INDEPENDENT HEARING AND ASSESSMENT PANEL
CONCEPT PLAN FOR CATHERINE HILL BAY & GWANDALAN

FINAL REPORT

The Independent Hearing and Assessment Panel for Catherine Hill Bay and Gwandalan has prepared this report to provide the Minister for Planning with its final views on the Catherine Hill Bay and Gwandalan Concept Plan and Project Applications submitted by the Rose Property Group Pty Ltd.

CATHERINE HILL BAY CLIFF LINE ANALYSIS

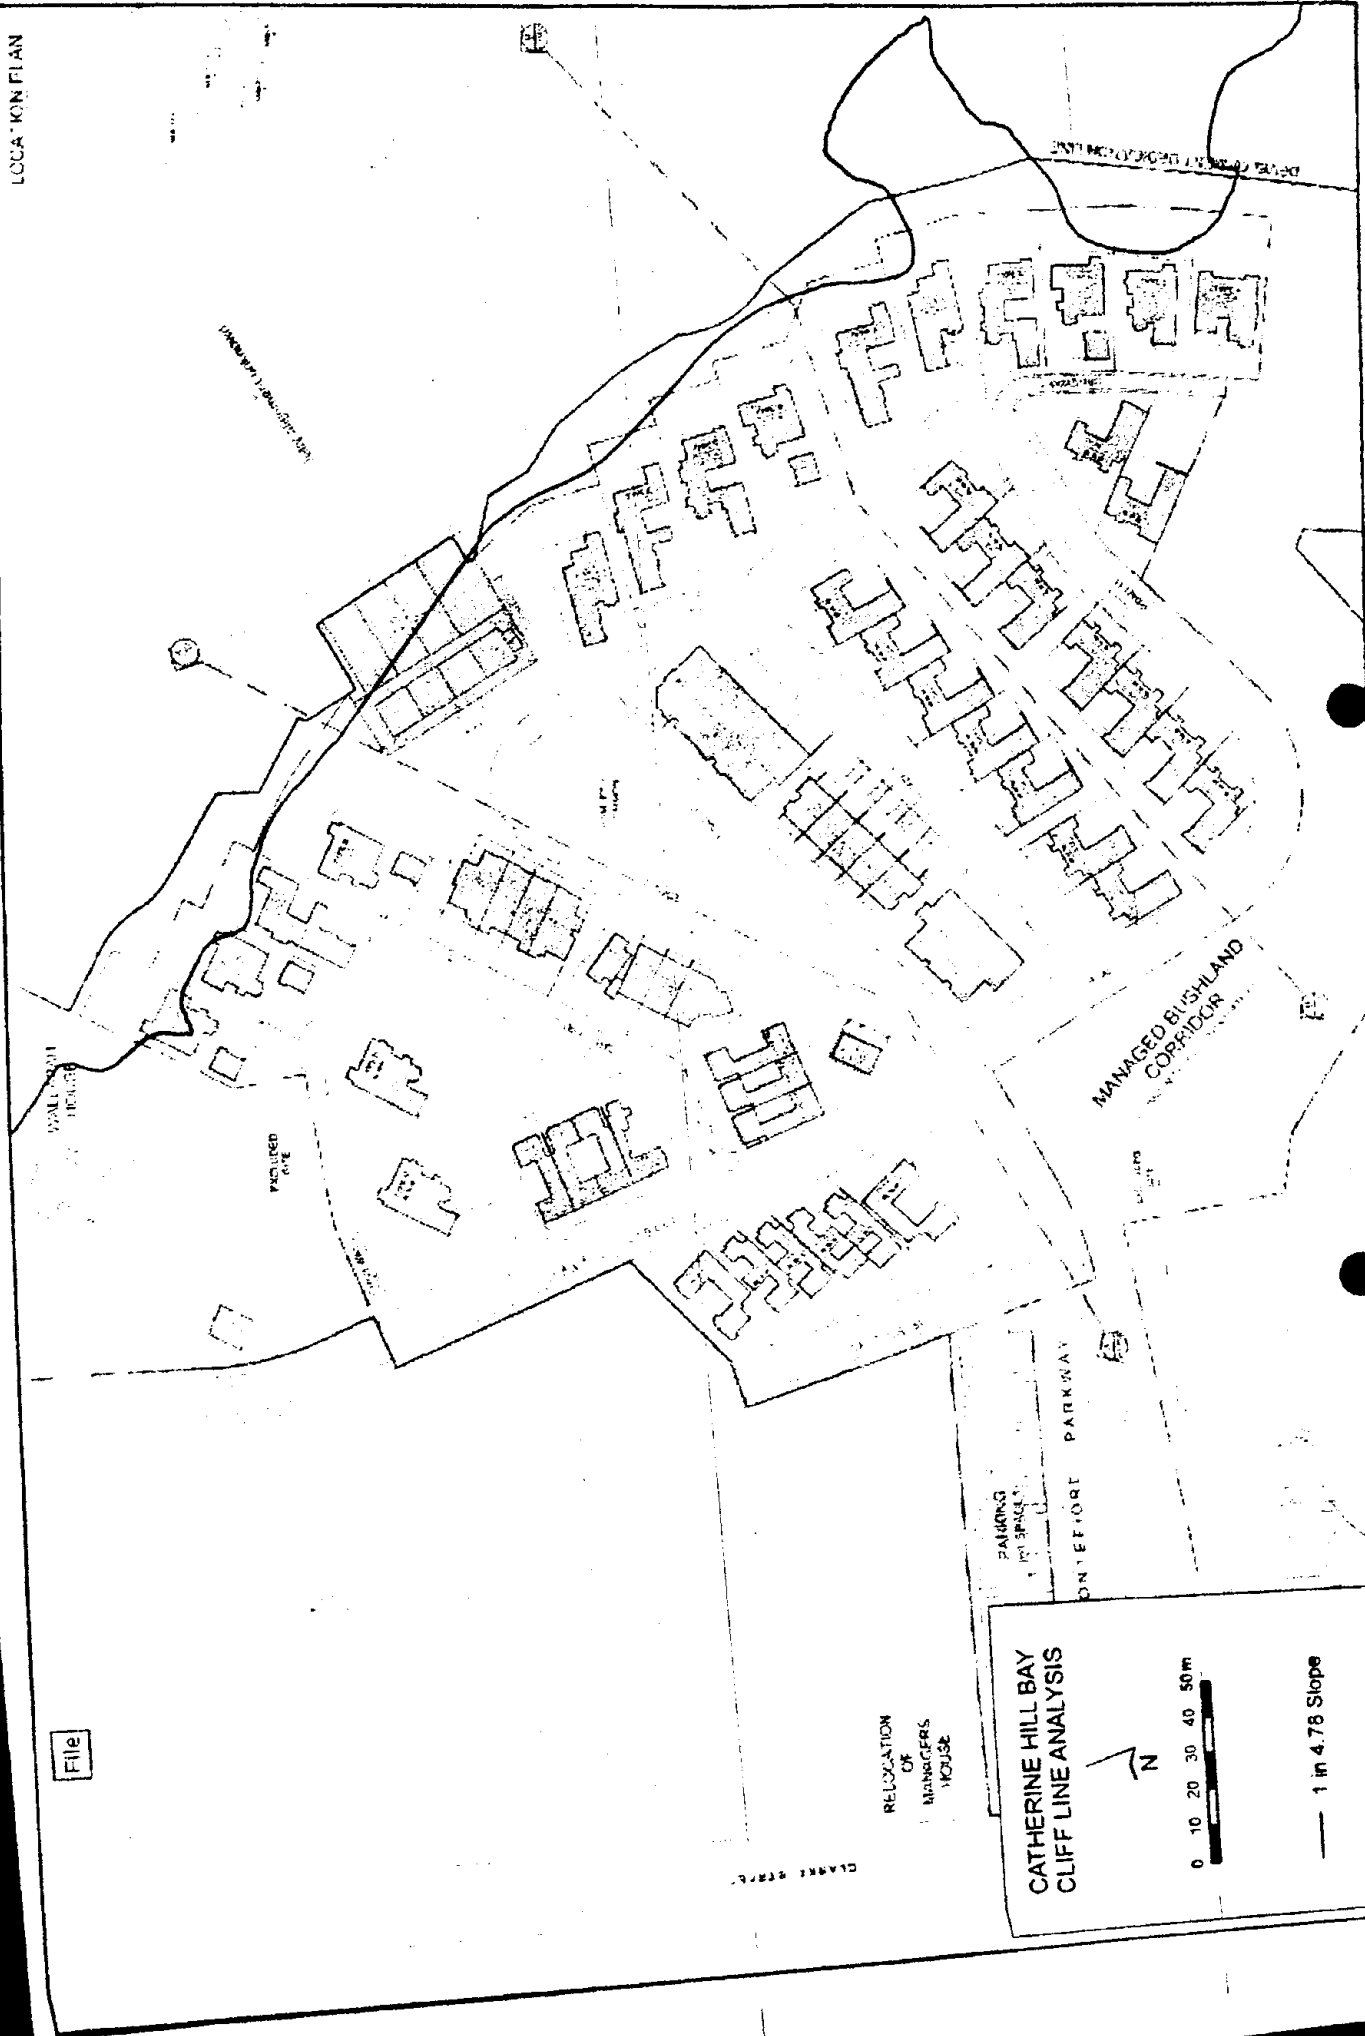
The Panel considers that the proposed treatment of the coastal walk and adjacent private residential development is clearly inconsistent with these guidelines and with best practice coastal planning. At the request of the Panel 3D modelling has been undertaken to identify the cliff line. The rationale for the identification of the cliff line is as outlined below by the Department of Planning:

The Panel is of the view that the proposed coastal walk should be a minimum width of 25m to ensure adequate width for the walk itself and an appropriate setback from the cliff edge to mitigate against cliff retreat, ensure cliff stability etc.

For the purpose of identifying the 25m setback requirement the Panel recommends that the "cliff edge" is defined as the line that represents the point where the land at the cliff edge has a slope of 1 in 4.78 or 20.9% (refer Figure 1 in main body of report).

For the purpose of identifying the 25m setback requirement the Panel recommends that the "cliff edge" is defined as the line that represents the point where the land at the cliff edge has a slope of 1 in 4.78 or 20.9% (refer Figure 1 in main body of report).
